DOCUMENT 00 90 00
ADDENDUM

ADDENDUM No.: 1

RE: LOGAN HS HVAC UPGRADES
SCHOOL DISTRICT OF LA CROSSE
1500 RANGER DRIVE
LA CROSSE, WI 54603
PROJECT NO. 22057

M202

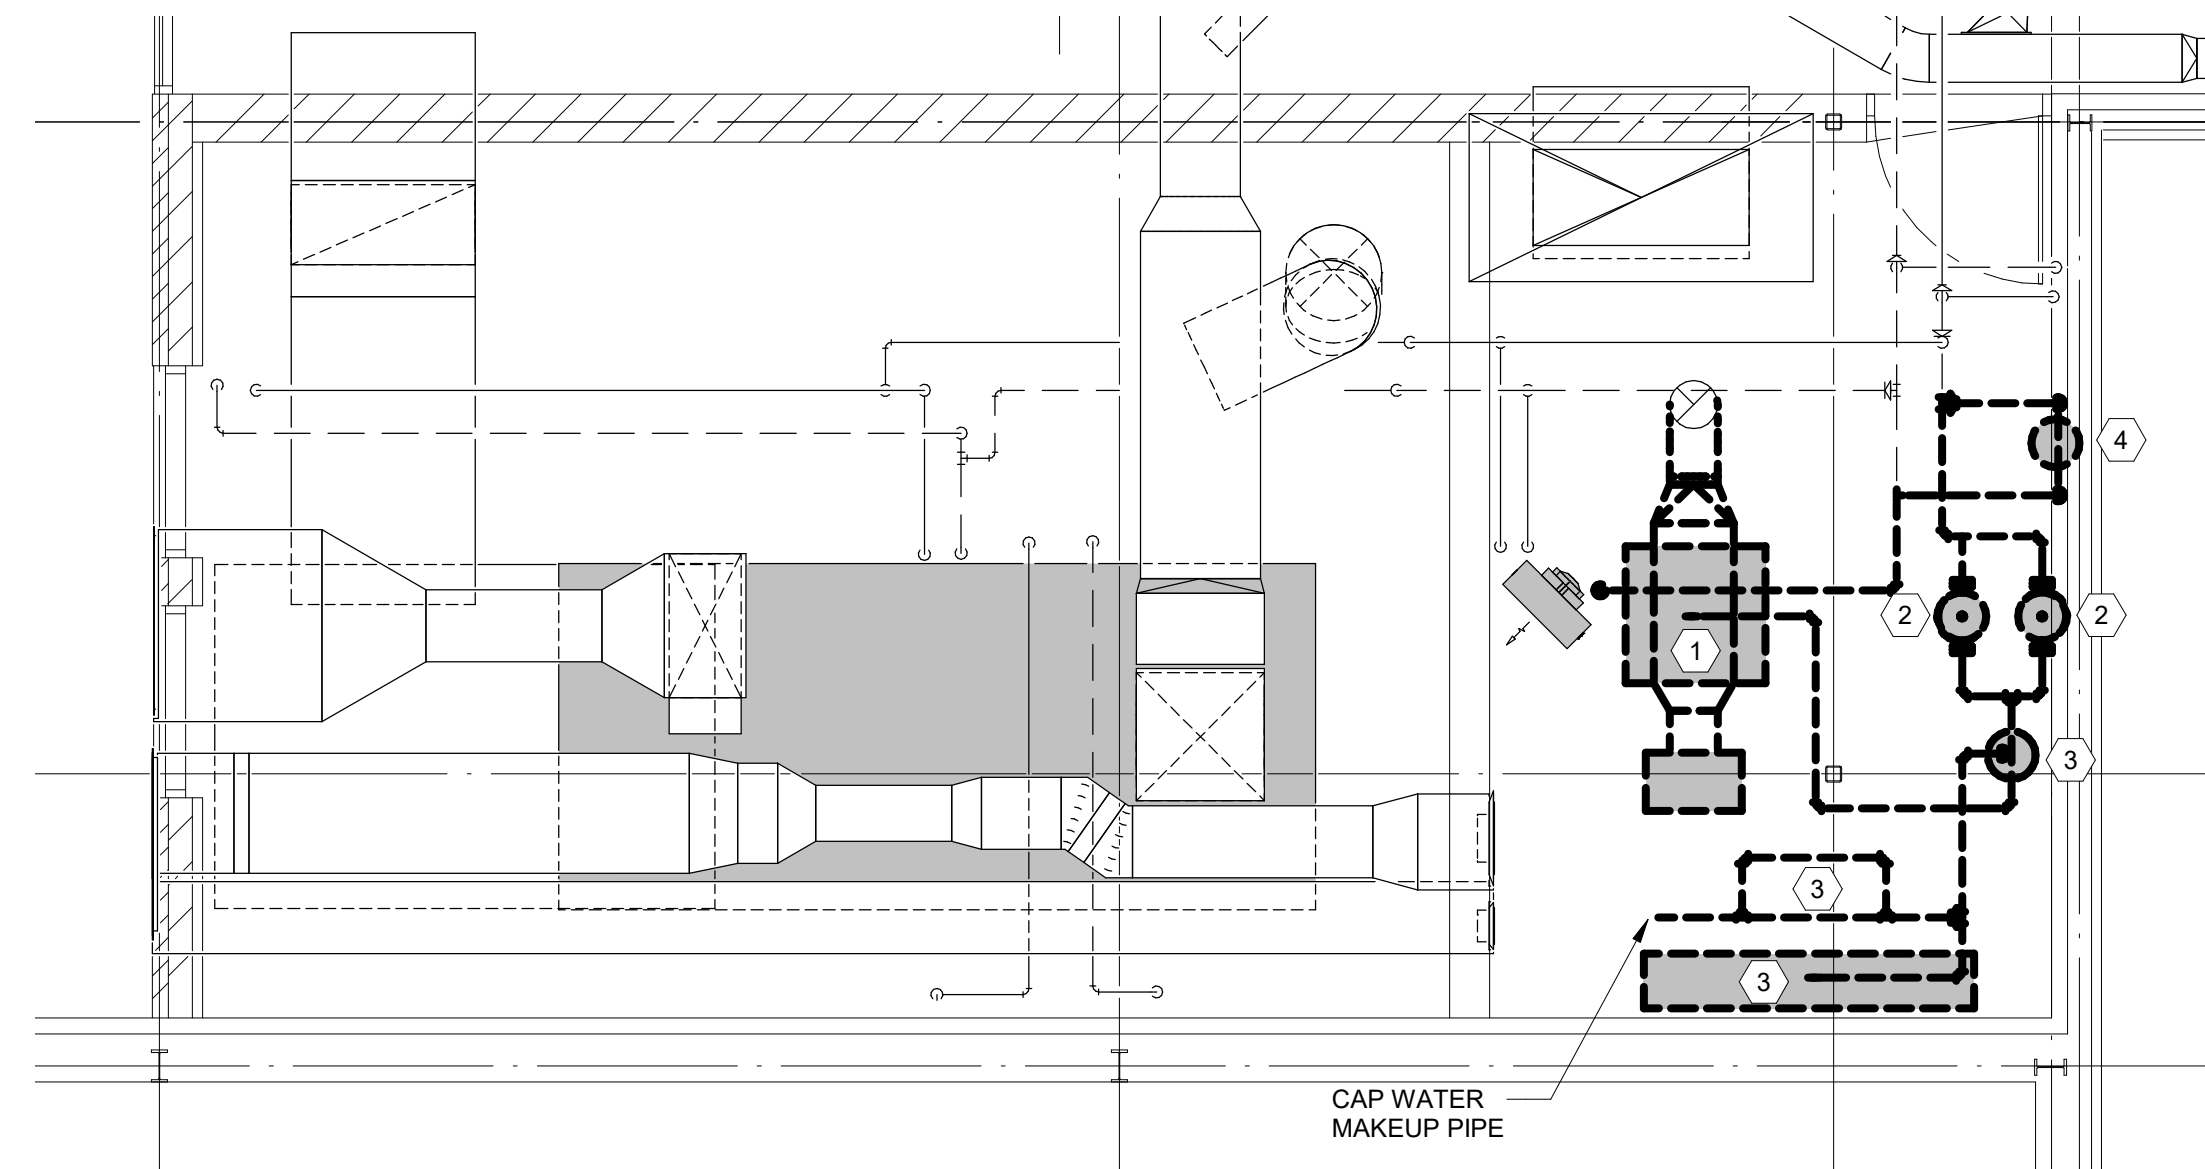
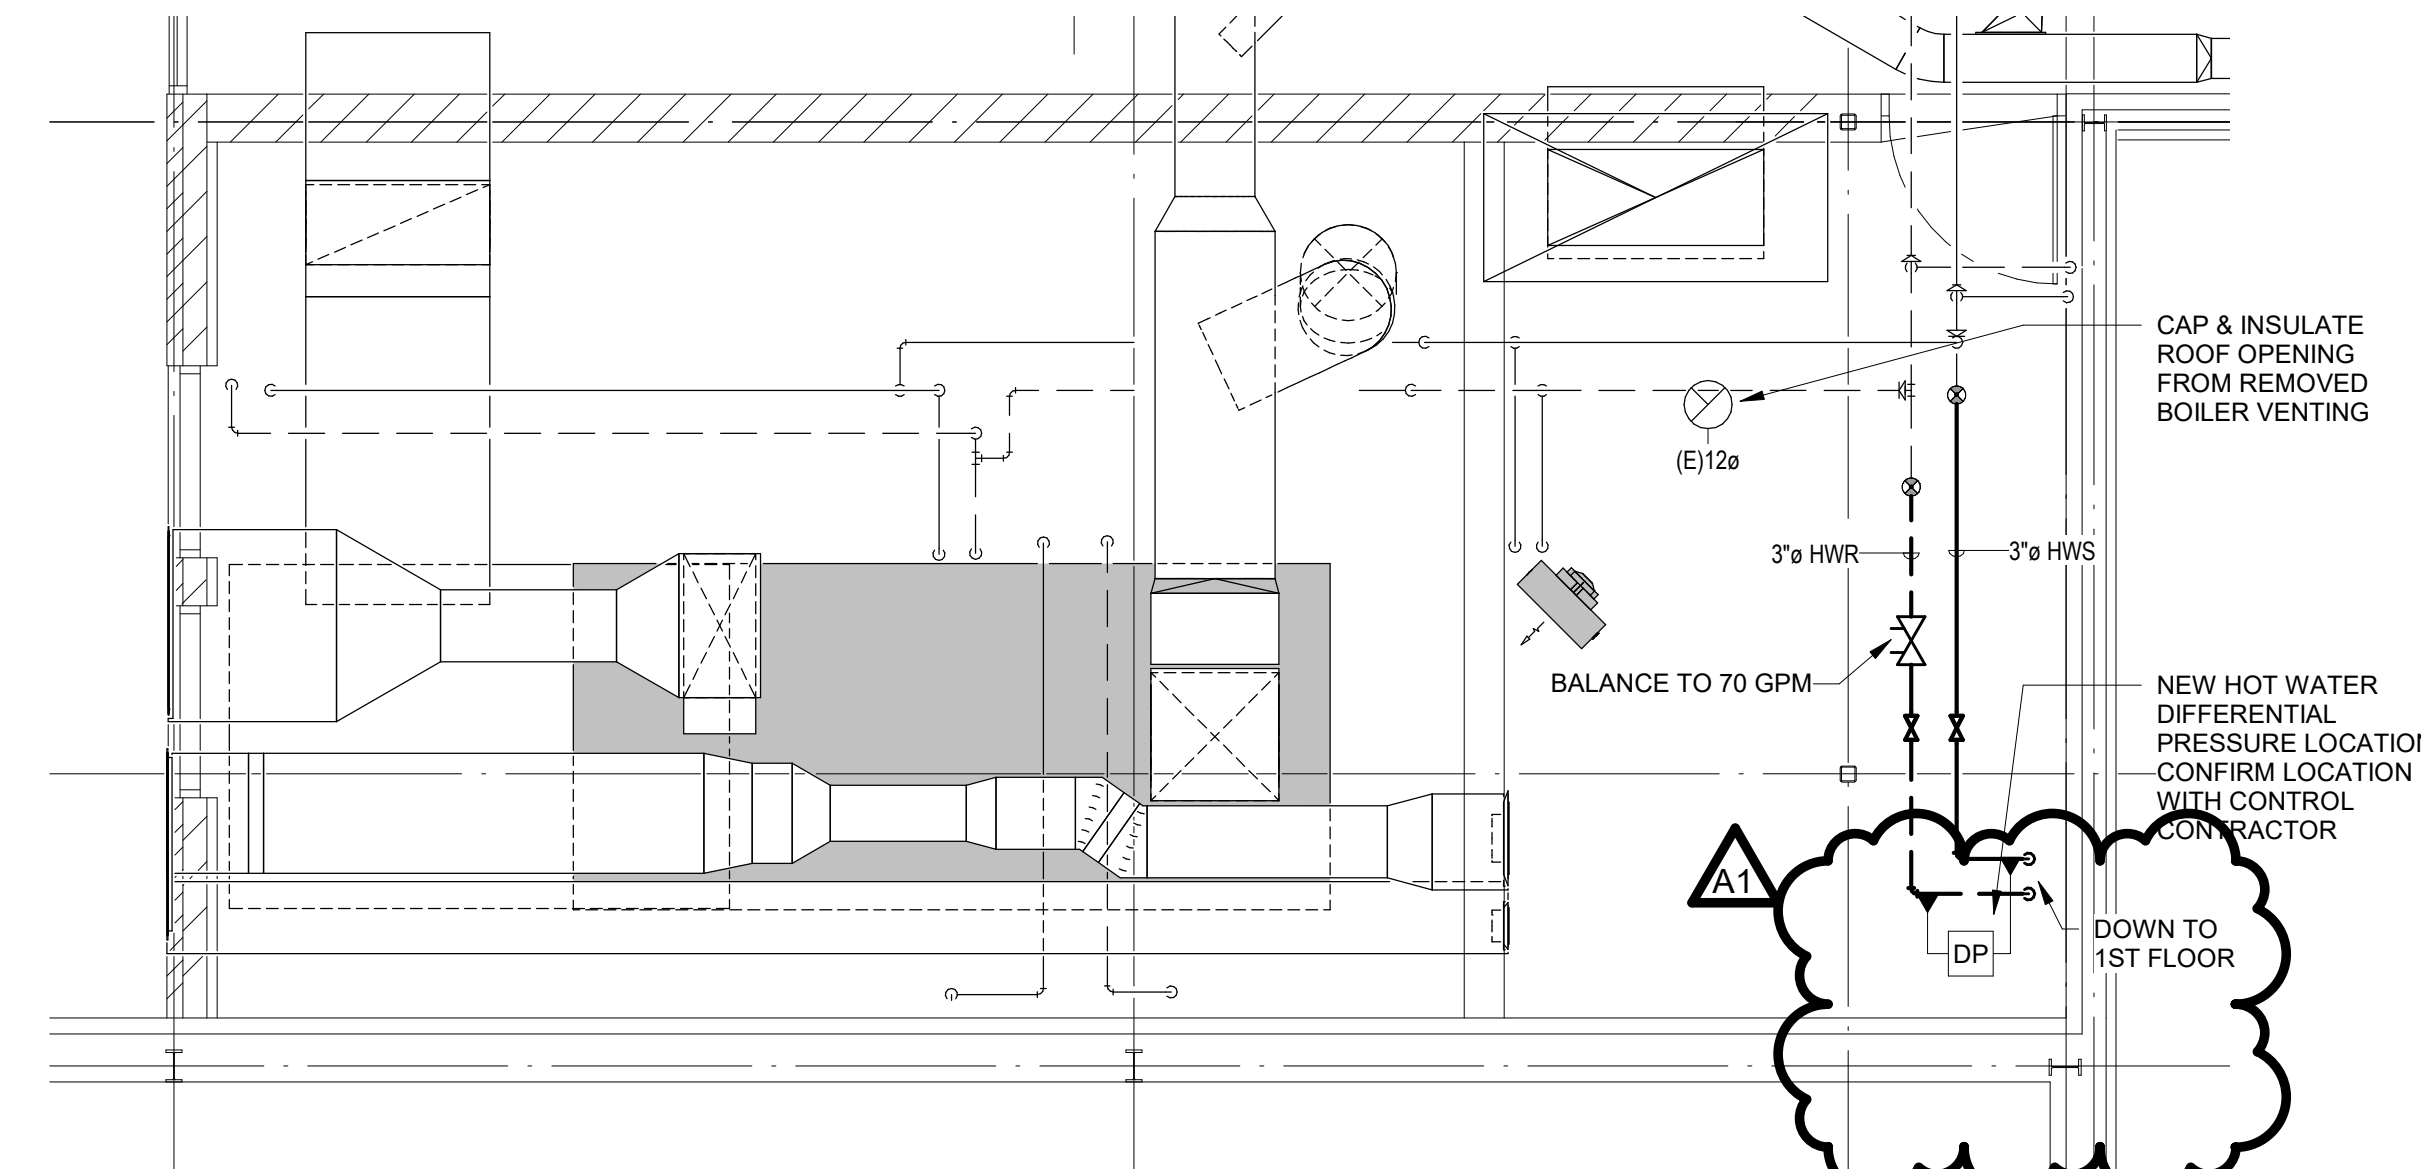
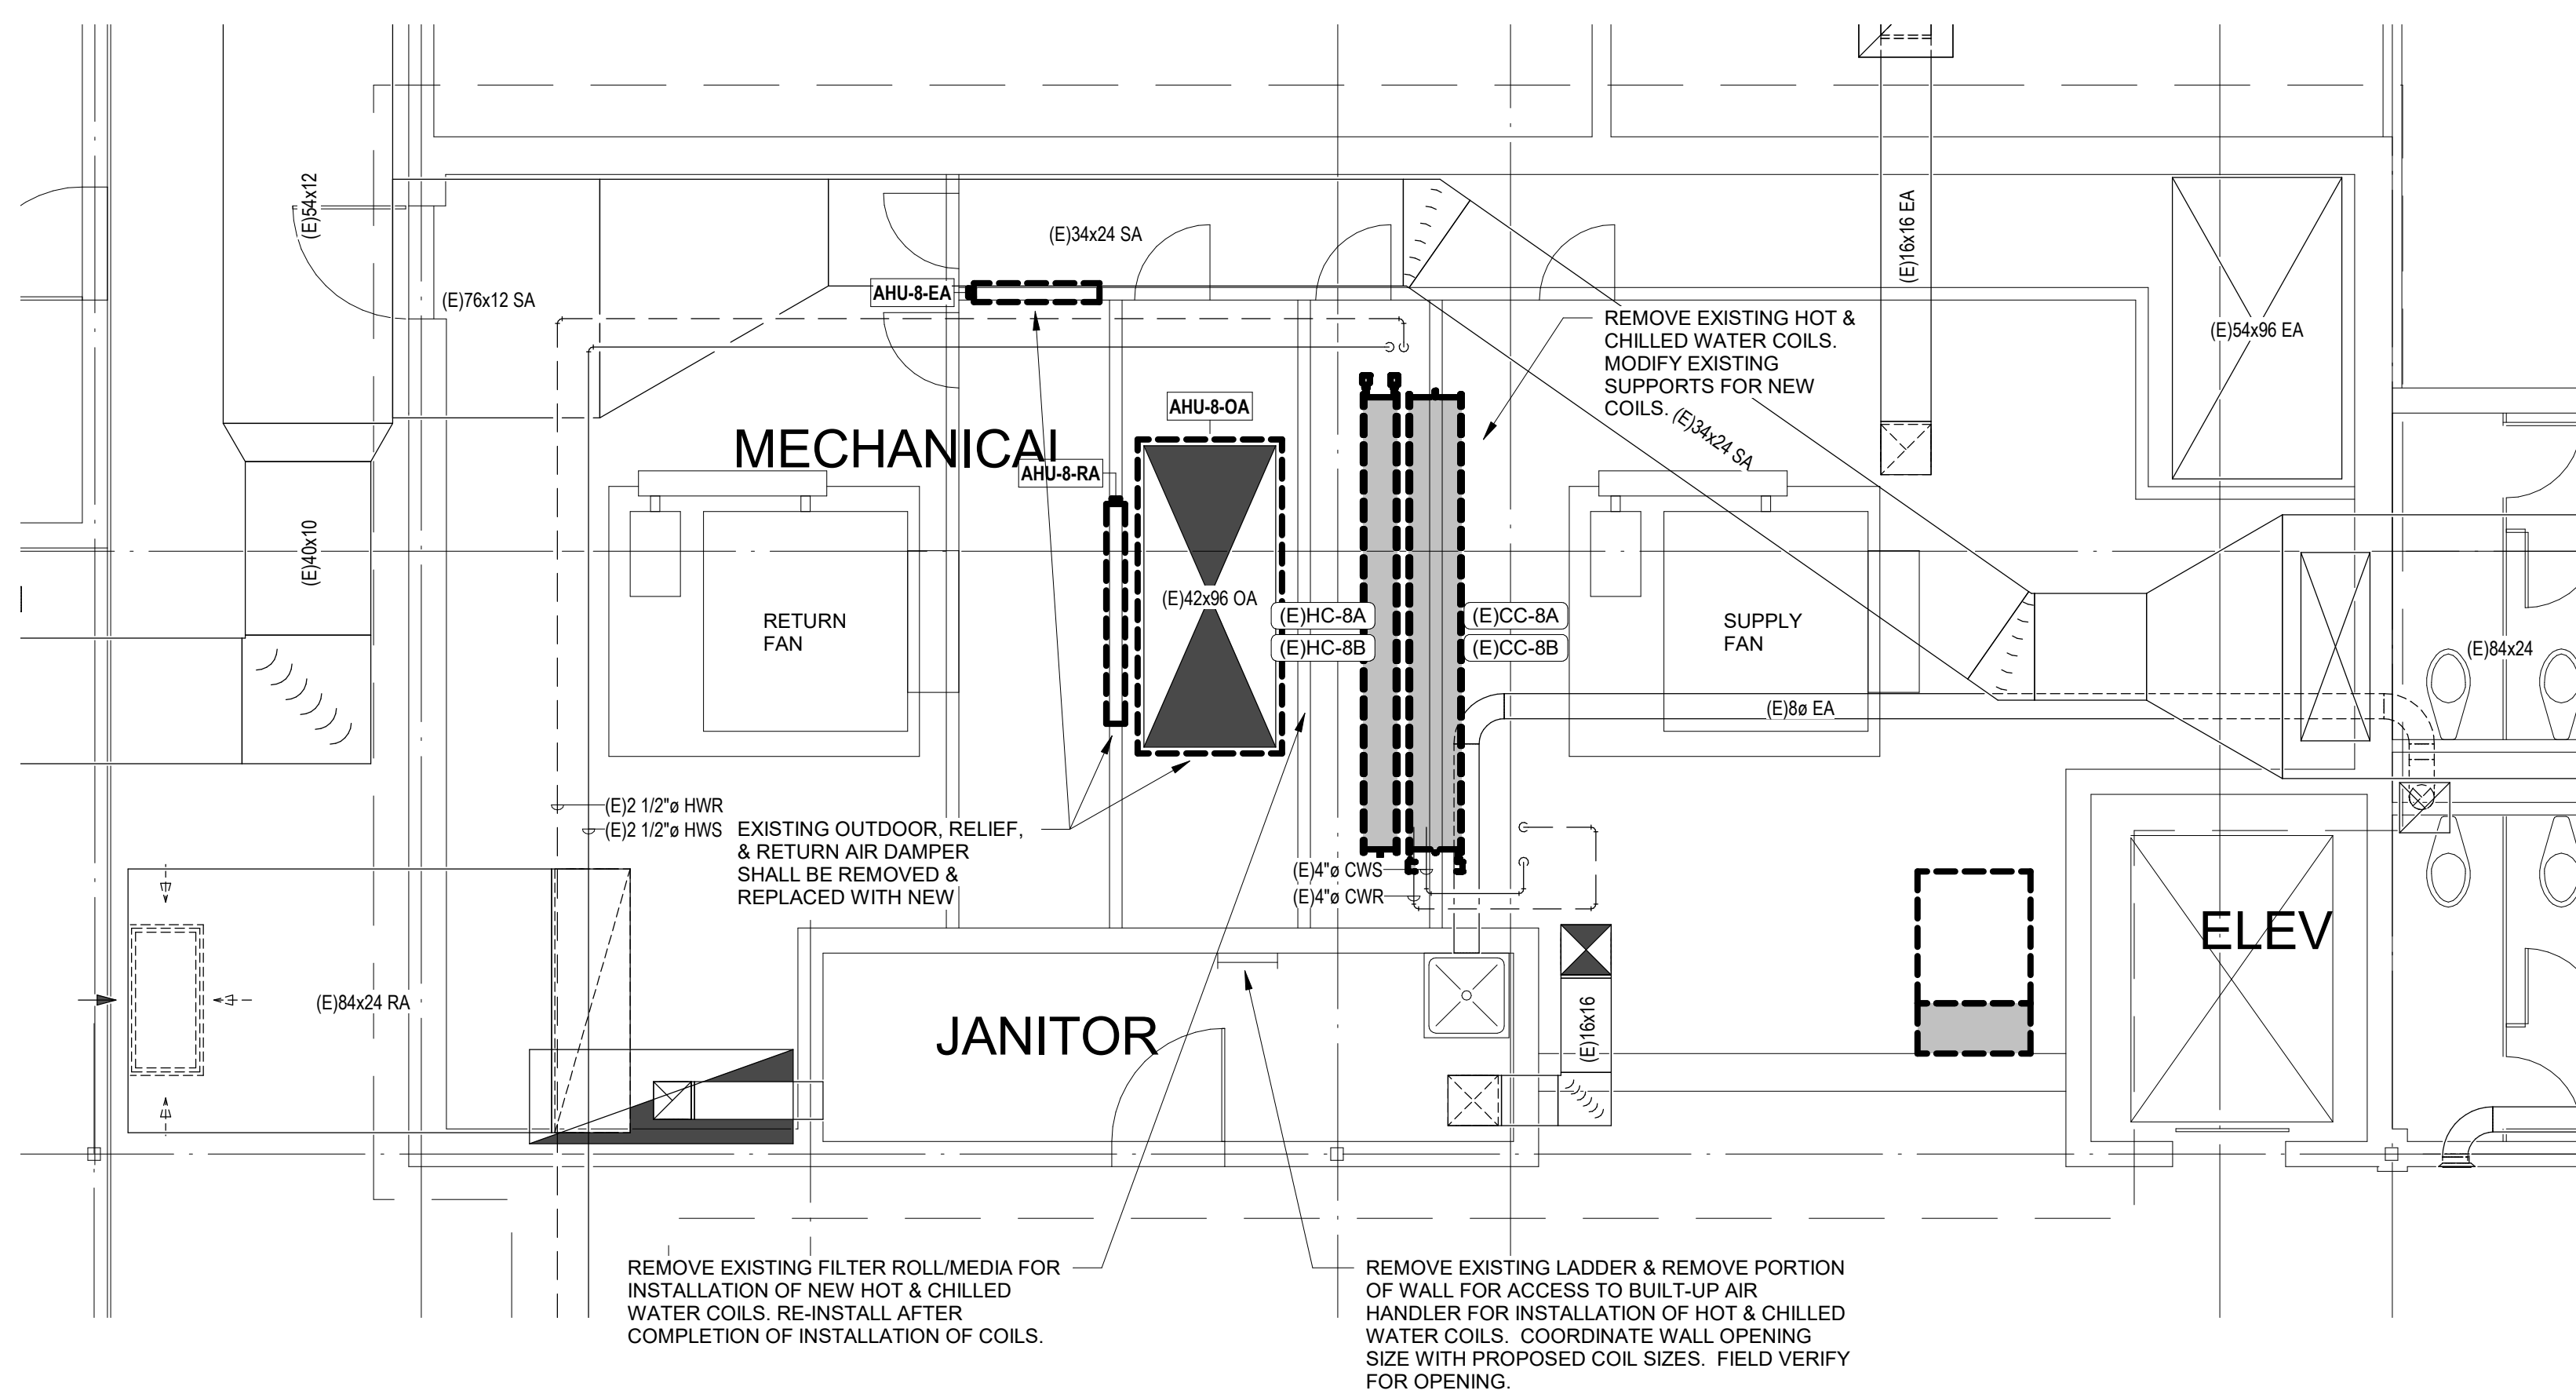
5. Sheet M201 ENLARGED PLANS 30"x42"
 - a. See the revised sheet included in this addendum. Disregard the previous version.
 - b. Added motorized dampers (E)PF-1 and (E)PF-2 to floor plan.
6. Sheet M202 ENLARGED PLANS 30"x42"
 - a. See the revised sheet included in this addendum. Disregard the previous version.
 - b. Modified routing of new 3" HWS/HWR piping to come through the floor of the 1995 Boiler Room.
7. Sheet M601 HVAC SCHEDULES 30"x42"
 - a. See the revised sheet included in this addendum. Disregard the previous version.
 - b. Added (E)PF-1 and (E)PF-2 to Motorized Damper Schedule.
8. Sheet E103 ELEC. REMOVAL AND REMODEL PLAN 30"x42"
 - a. See the revised sheet included in this addendum. Disregard the previous version.
 - b. Add motors HWP-1 and HWP-2 to Motor Schedule
 - c. Add Note #4 to motor schedule remarks.
 - d. Revised remarks column in motor schedule.
